Great Musgrave EDE/25

Report for The HRE Group

Revision A, 9 May 2022

BILL HARVEY ASSOCIATES LTD.

Figure 4.2: Plan dimensions from 1998 assessment report.

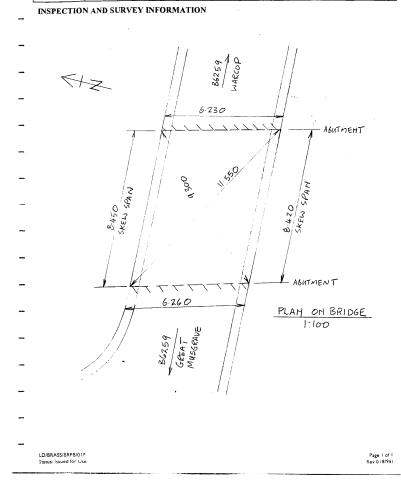
Figure 4.2 gives plan dimensions, with widths at each abutment, skew span at each elevation, and both diagonals.

We can estimate the skew angle from the span, width and diagonal dims using the cosine rule (eqn 4.1, with terms as shown in figure 4.1). Depending on the triangle chosen, the skew comes out at 12.7° to 12.8° .

Thus the centres were 27 foot span and placed square to the abutments.

Figure 4.3: South elevation dimensions from 1998 assessment report.

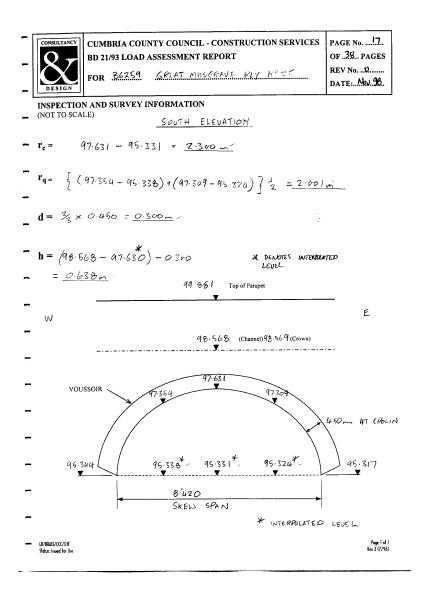
Figure 4.3 shows the south elevation dimensions. These are shown as levels, measured at the springings, quarter points, and crown.

We do not know how these levels were obtained. Measurements are reported to the nearest millimetre, which is unjustifiable whatever the method. The level difference at the springings of 30 mm is surprising and would warrant comment and checking. Quarter point measurements are particularly difficult, as the they are very sensitive to position in the span.

Crown and quarter point rise can be obtained from these by substracting soffit level from springing level. The crown rise is 2300 mm, or 7.55 feet. That this is slightly over 7.5 feet is a little surprising. The arch will normally drop at de-centring, and a rise that falls slightly short of a round number in fractional feet is more

27/7.5 gives a span:rise ratio of 3.6, which again is unusual. 7.5 feet would be a common rise for a 30 foot span, giving a 4:1 span:rise ratio.

Figure 4.4: North elevation dimensions from 1998 assessment report.

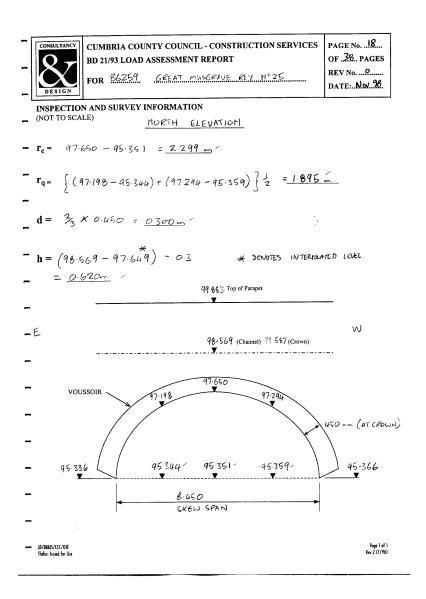
Looking now at the north elevation, dimensions in figure 4.4, things get less convincing. The 20 mm difference in level between the abutments is repeated here, but a drop of this scale across the span would show as distress in the spandrel wall masonry. A 20 mm level difference between elevations is also suggested, and

Rather than addressing the question of whether these tilts are real and, if they are, how they might have come about and what that means for the bridge, the 1998 assessment proceeds by taking them as given and interpolating between them.

These values for levels and rise show a range of deviations from likely truth. The bridge was undoubtedly level across both span and width at construction. Tilts of 20 mm in both directions would surely have visible effects.

Figure 5.1: A recent photograph showing elevation and soffit.

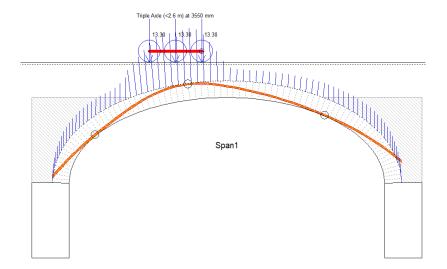
Figure 5.1 gives a view of the elevation and soffit. The water marks suggest backing at least to the sixth voussoir from the end but more likely the ninth, which would be more or less level with the arch crown intrados.

Figure 5.2: Worst case AWR load for Great Musgrave geometry, with backing to crown intrados level.

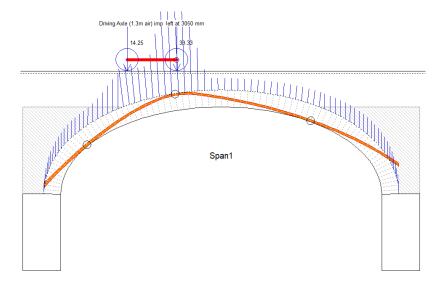
On that basis, the bridge would suffer no damage from any AWR vehicle. The worst case would be as shown in figure 5.2. For loads with impact, the worst case is shown in figure 5.3

Sensible application of either Modified MEXE or the Archie-M approach shows a capacity in excess of that required for 44 tonne vehicles.
